337 MONTGOMERY STREET RESIDENTIAL DEVELOPMENT OTTAWA

SITE PLAN CONTROL APPLICATION

DESIGN BRIEF

September 2019

SITE PLAN - THE SUBJECT LANDS ARE ZONED R5C H(25)

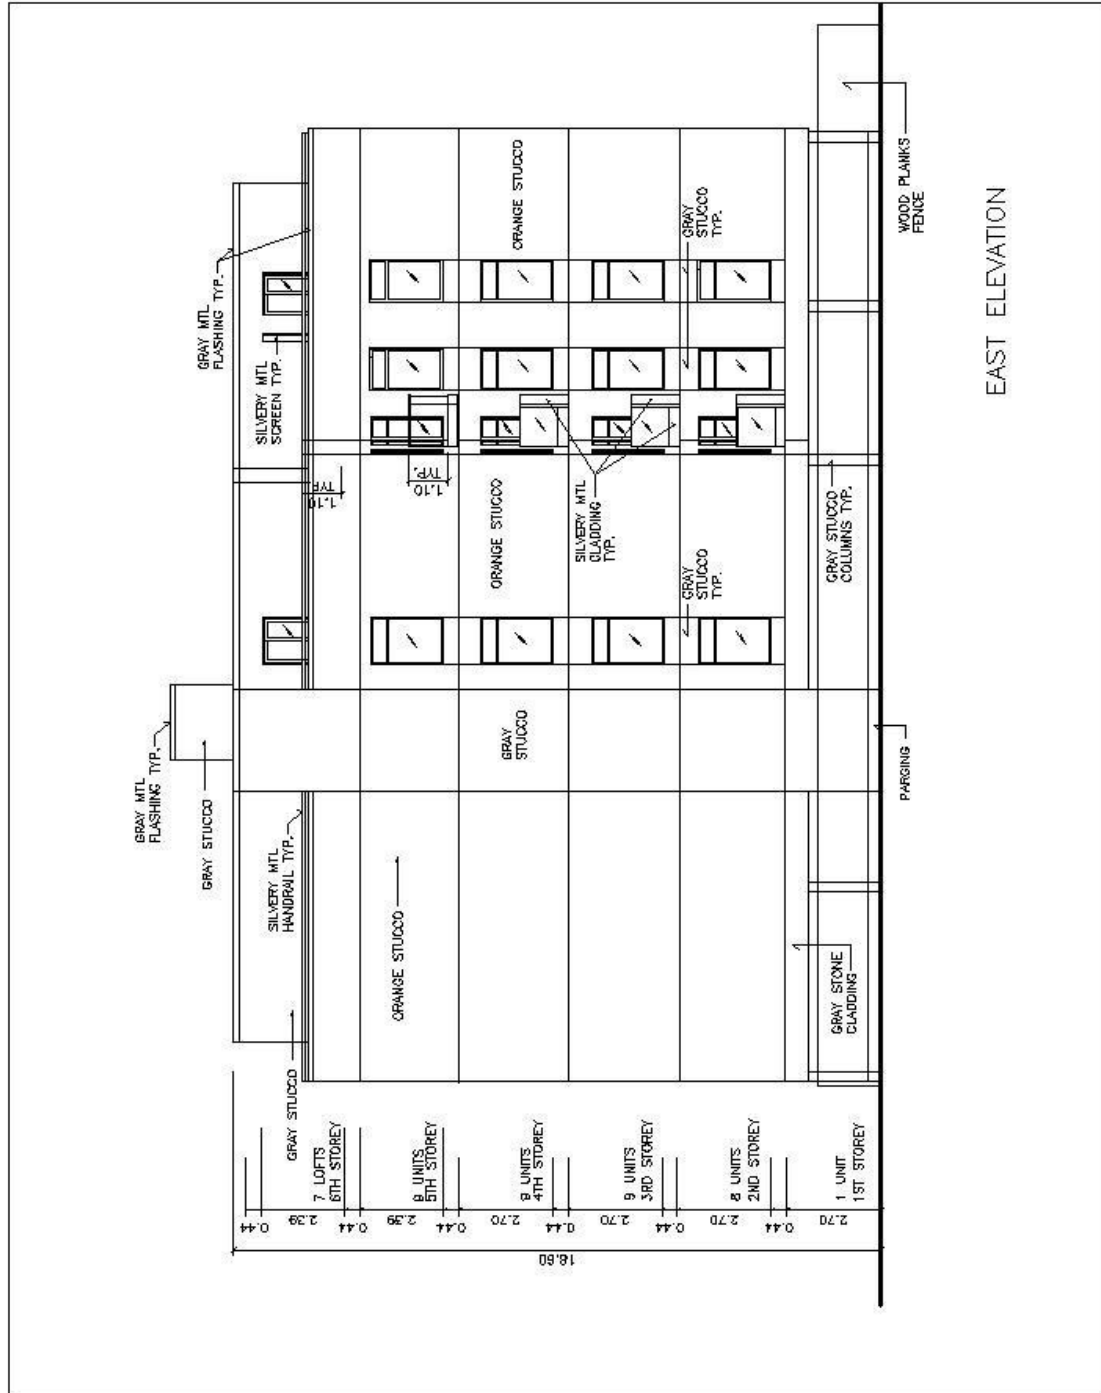
Planning Comments

- The bicycle parking has been moved from street level to the basement (15 spaces). 5 spaces remaining above grade will serve to the commercial use.
- One uncovered car parking was eliminated, remaining 14 covered spaces comply with the Zoning requirements.
-
- The proposed development complies with the Montreal Road District Secondary Plan.
- The property is not on the Heritage Register.
- The enclosed parking doesn't require a landscaping buffer.
- The waste management was based on the City requirements.
- The outdoor commercial patio was removed.
- The TIA Screening Form has been submitted.
